## **RESPONSE TO CONSULTATION RESPONSES FROM NATURAL ENGLAND DATED 4 MAY AND 16 JUNE 2010**

- 1.1 This note responds to the request for clarification and further information set out in NE's letters of 4 May and 16 June to the North York Moors National Park Authority and North Yorkshire County Council respectively.

App'd: KL	Drawn: SQ	Date: JULY 2010
		Ref: KL/SQ/MCH
Scale: AS SHOWN		Job No: 49306721
Drg. Size: A3		<b>FIGURE 1</b>

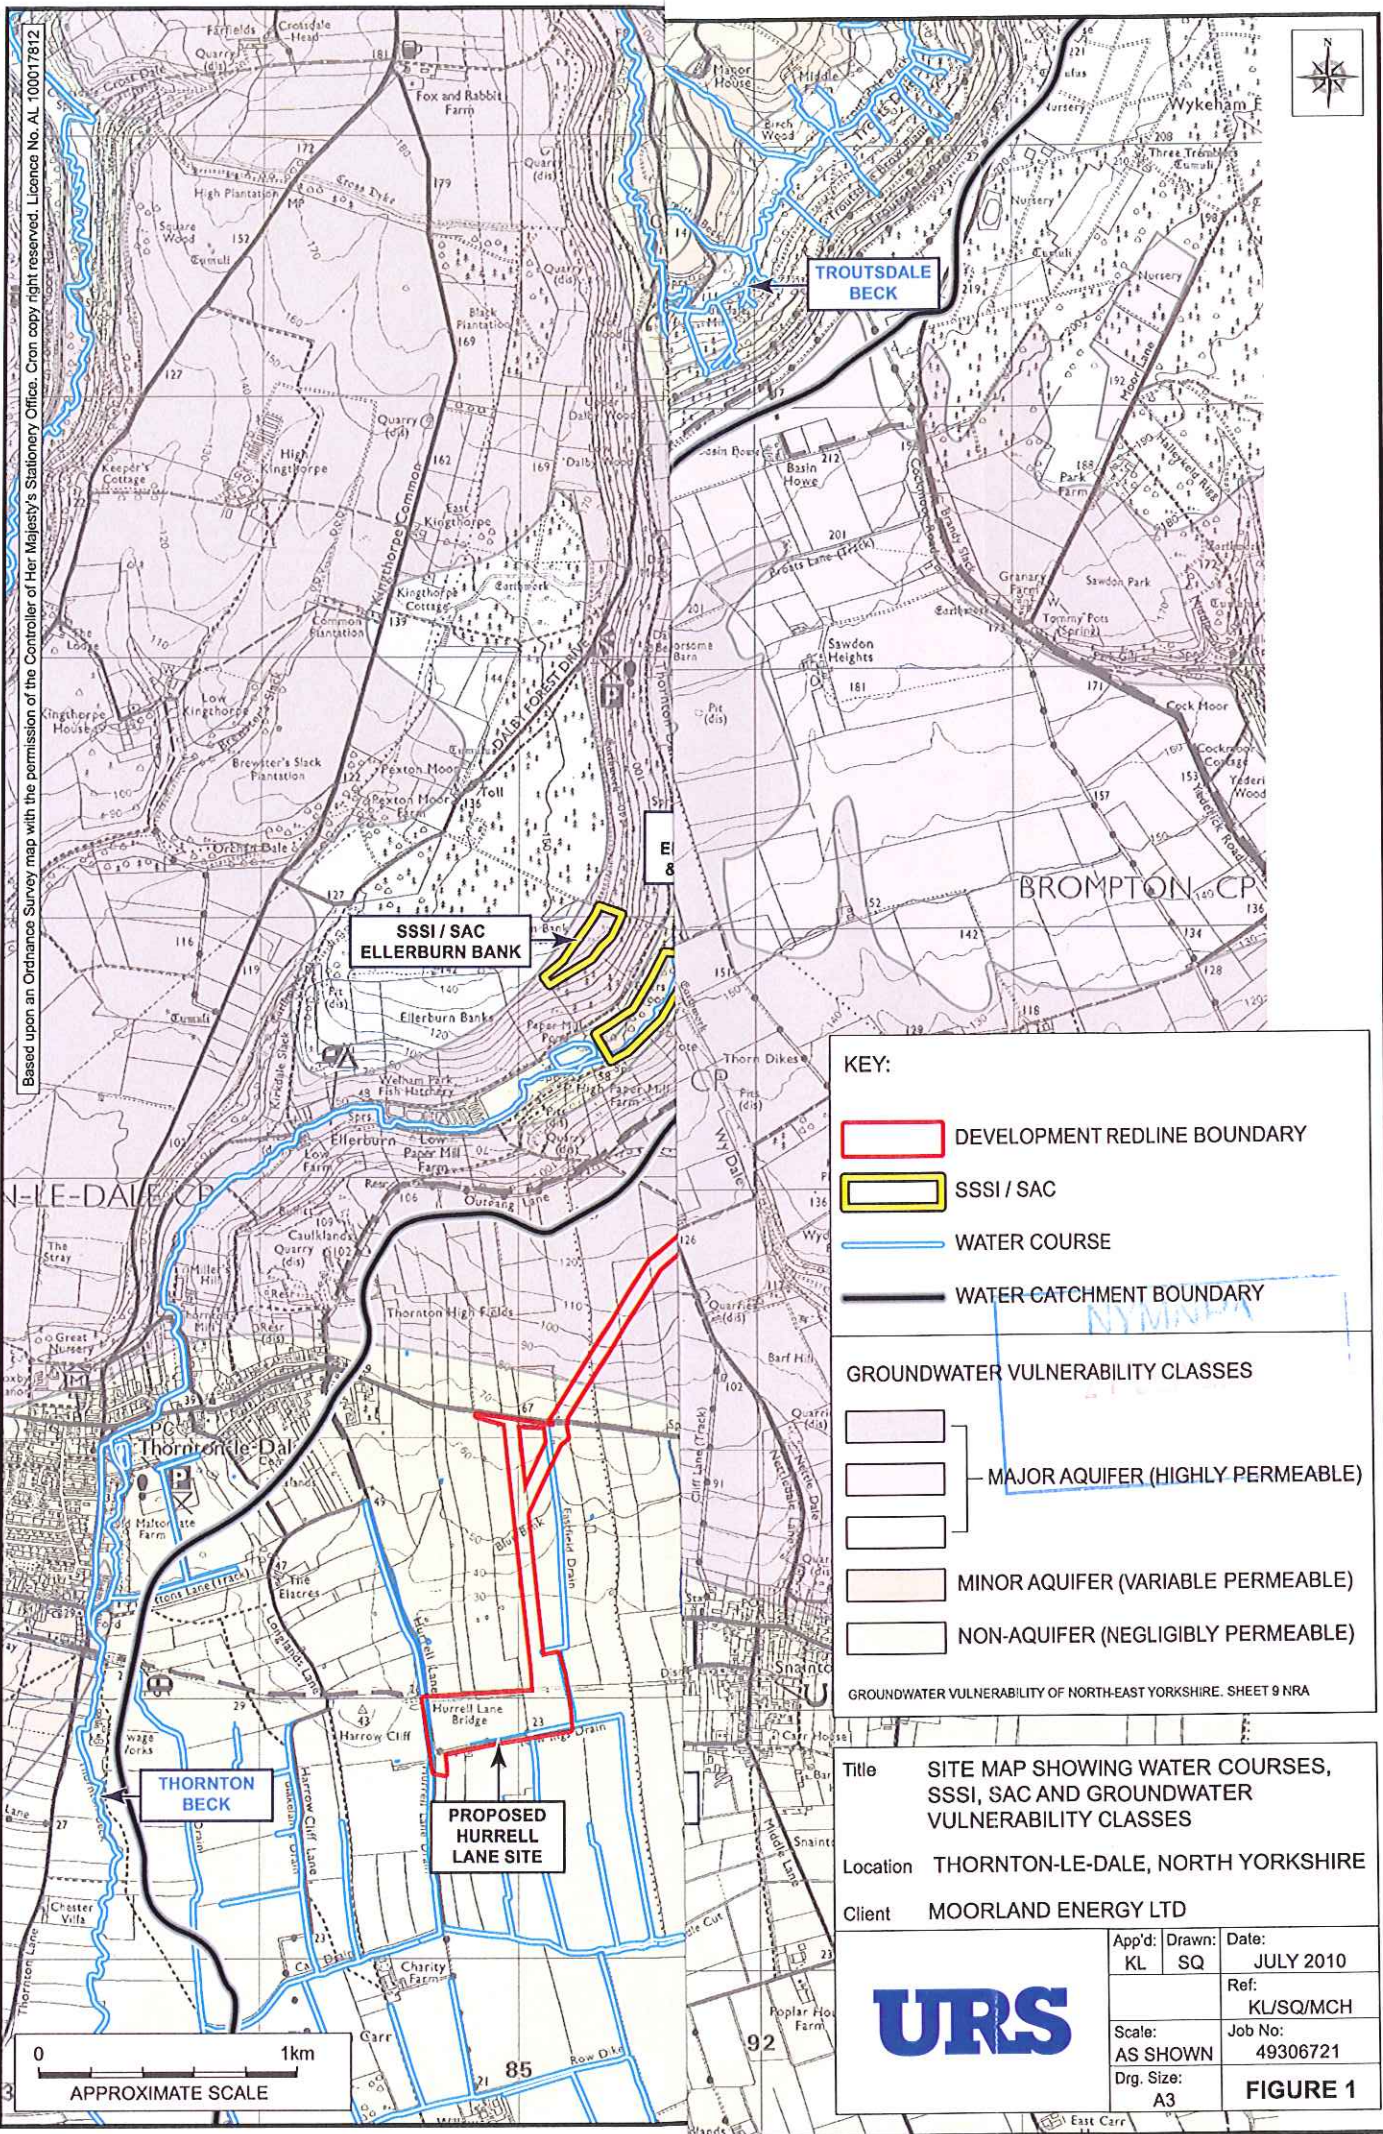
- 1.15 **Figure 1 (Appendix 1)** shows the location of the SSSI and SACs in relation to the main surface watercourses in the area. In addition, the catchment boundaries obtained from the Flood Estimation Handbook (FEH) CD Rom are marked to provide, together with background Ordnance Survey contours, an indication of the areas likely to be affected by runoff generated on or flowing over the pipeline route. These show that in the areas upstream of the SSSIs and SAC, the pipeline is located along a watershed, and possibly outside the catchments with SSSIs and SACs. The pipeline route will cover a small strip of land, and be reinstated after construction. It is therefore expected to have negligible impact on the surface water environment. Standard controls during construction will prevent adverse surface water effects on the ecological integrity of the designated sites.

- 1.16 Figure 1 also shows the route of the pipeline along the main aquifer zones. Most of the pipeline lies on the Corallian Limestone Aquifer. The aquifer is highly permeable, and coupled with the location of the pipeline route along high ground and shallow excavation depths, the likelihood of encountering groundwater is small. According to

the Environment Agency, the groundwater levels are likely to be high at the boundary to Amptill Clay and Kimmeridge Clay. The boundary between the clay formations and the Corallian Limestone lies immediately north of the A170 road, more than 1km from the nearest designated site. URS understands that much of the EA's monitoring is in the lower-lying valley along the A170 road, where many of the settlements and associated abstractions are located. The locations of springs have therefore been used to provide an indication of groundwater levels in the vicinity of the pipeline route. To the north of the start of the pipeline at Ebberston Well site, the Ordnance Survey background map included in Figure 1 indicates that the springs around Troutsdale Beck lie over 60m below the site. Similarly, the spring at the start of Allerston Beck lies approximately 60m below the pipeline route in that vicinity. Given the large elevation differences, URS consider that it is highly unlikely that groundwater will be encountered along its route near the SSSIs and SACs.

- 1.17 Substantive dewatering requirements are therefore anticipated to be limited to shallow excavations over a short length of the pipeline route to the south of the geological boundary, near to the A170 road. This is at much lower level than the SSSI and SAC and is more than 1km from these designated areas, so will not affect flow of water into or out of the designated areas. Effects on groundwater will be very localised (low magnitude), of short duration and changes in the groundwater gradient would be negligible at the designated sites due to the distance between the pipeline route and the designated sites. Therefore no effects on the ecological integrity of the SSSI and SAC designations are expected as a result of localised and distant hydrogeological changes.
